REGULATOR INFORMATION DISTRIBUTION ITEM (RIDS)

SUBJECT: Forwards responses to Auxiliary Sys Branch draft SER Open
 Items 134, 135 & 224, re removal of barrier in fuel cask pool,
 crane load block & protection of circulating water sys.

SHEARON HARRIS NUCLEAR POWER PLANT
UNIT NOS. 1 AND 2
DOCKET NOS. 50-400 AND 50-401
DRAFT SAFETY EVALUATION REPORT RESPONSES
AUXILIARY SYSTEMS BRANCH

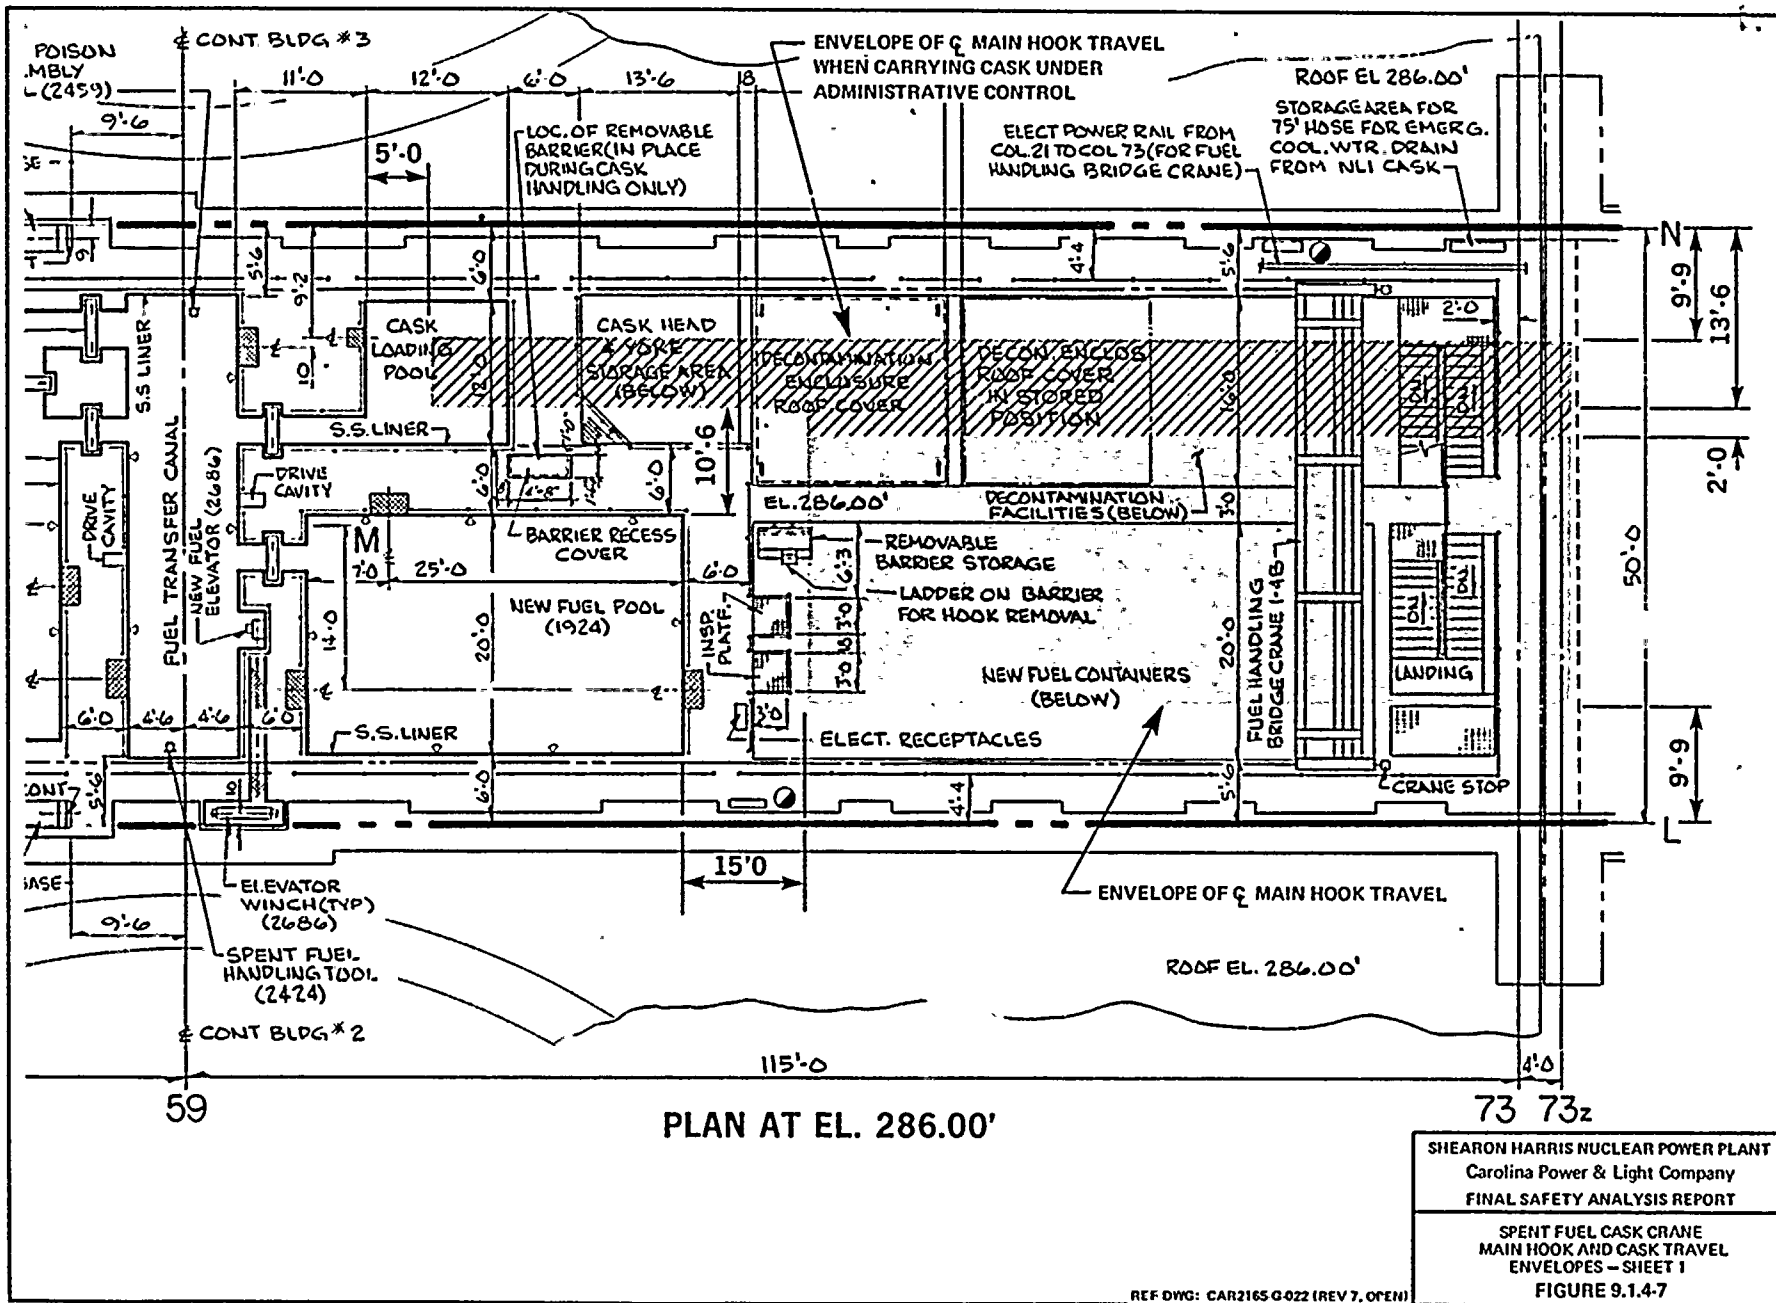
Provide additional information indicating how the removal barrier placed between the cask loading pool and the new fuel pool will prevent the spent fuel cask-handling crane from being inadvertently moved over the new fuel pool. We are concerned that since the new fuel pools may be flooded and used for storage of spent fuel, only administrative controls could prevent a heavy load on the spent fuel cask crane from moving over this spent fuel. Describe the design of the removal barrier, its stability against side thrust of the spent fuel cask, its resting position should it be toppled by the spent fuel cask and clearance around the in-place removable barrier to the new fuel pool.

It is our position, based on NUREG-0612, Section 5.1.2, that mechanical or electrical stops be provided to restrict travel to the east from the cask loading area, and we are concerned that the removable barrier is an inadequate mechanical stop.

The removable barrier is not designed to prevent the cask crane from being inadvertently moved over the new fuel pool. The function of the removable barrier is to prevent the cask, in the remote chance of being dropped on top of the dividing wall between the cask loading pool and cask head and yoke storage area, from toppling over and falling into the new fuel pool. The dropping cask, after landing on the dividing wall, may start to topple over and strike the barrier. The barrier is designed to withstand the striking force, thus, preventing the cask from falling into the new fuel pool. The removable barrier is 21 feet 6 inches in overall height. It is set in place by being lowered into a 4 feet deep recess in the concrete floor; therefore, the installed height is 17 feet 6 inches measured from the operating floor.

Travel of the center line of the main hook on the cask crane is restricted to the shaded area as shown on Figure 9.1.4-7 by a combination of limit switches and mechanical stops. Figure 9.1.4-7 has been marked to show additional information and is attached. During cask handling, the center line of the main hook is further restricted under administrative control to the path cross hatched on the figure.

Therefore, a combination of limit switches and mechanical stops do restrict the crane from the new fuel pool area, and the removable barrier is not used as a mechanical stop. Refer to FSAR Section 9.1.4.2.2.7 for further details on the spent fuel cask handling crane and the auxiliary crane.

FIGURE 224-1

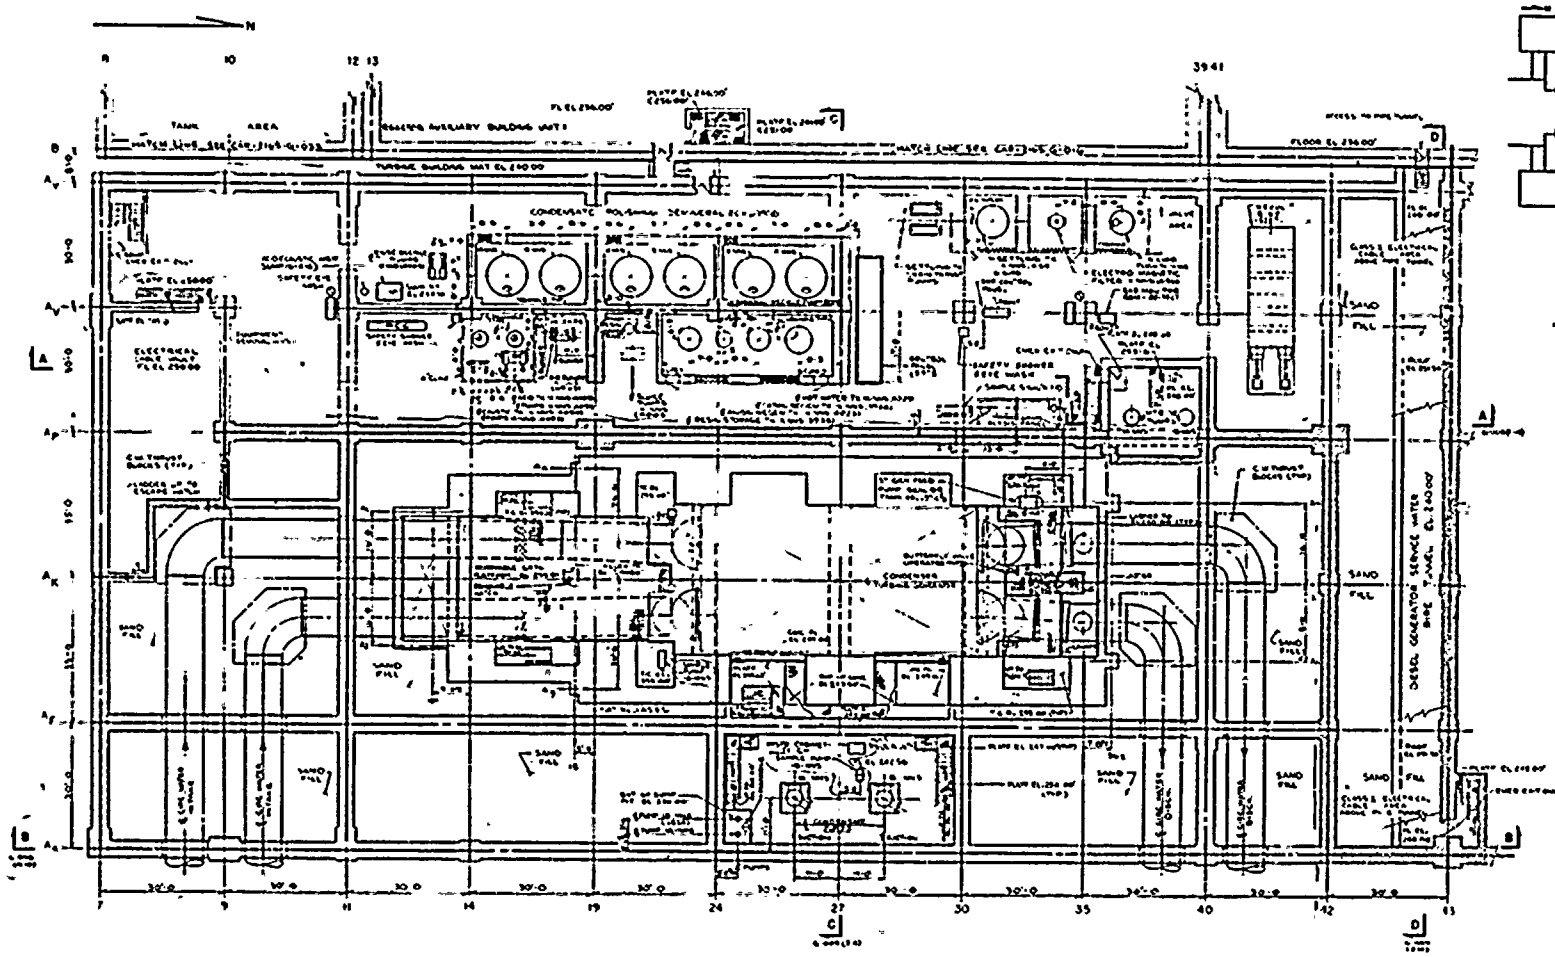
Demonstrate that the circulating water system meets the requirements of GDC 4 with respect to protection of safety related systems from failures in non-safety related systems. Postulated seismic failure of the circulating water piping allows water flow by gravity and siphoning to a common elevation in the cooling tower basin and turbine building basement. Water may reach several safety related areas via access from turbine building walls and doors not identified as seismic Category I and water proof for flooding.

The areas of the Turbine Building containing circulating water pipes are separated from the buildings with safety related areas by continuous reinforced concrete walls as shown by shading in Figures 224-1 and 224-2. These walls are seismically designed to resist the seismic forces of the SSE and hydrostatic pressure that would be associated with flooding up to elevation 262 feet.

As shown in Figure 224-1, the Unit 1 Turbine Building walls that isolate the circulating water pipe areas from safety related areas of the Reactor Auxiliary Building are the walls at column coordinates 7/Aa to 7/Ak, 7/Ak to 9/Ap, 9/Ap to 42/Ap, 42/Ap to 42/Aa, 42/Aa to 43/Aa, 43/Aa to 43/Ap.
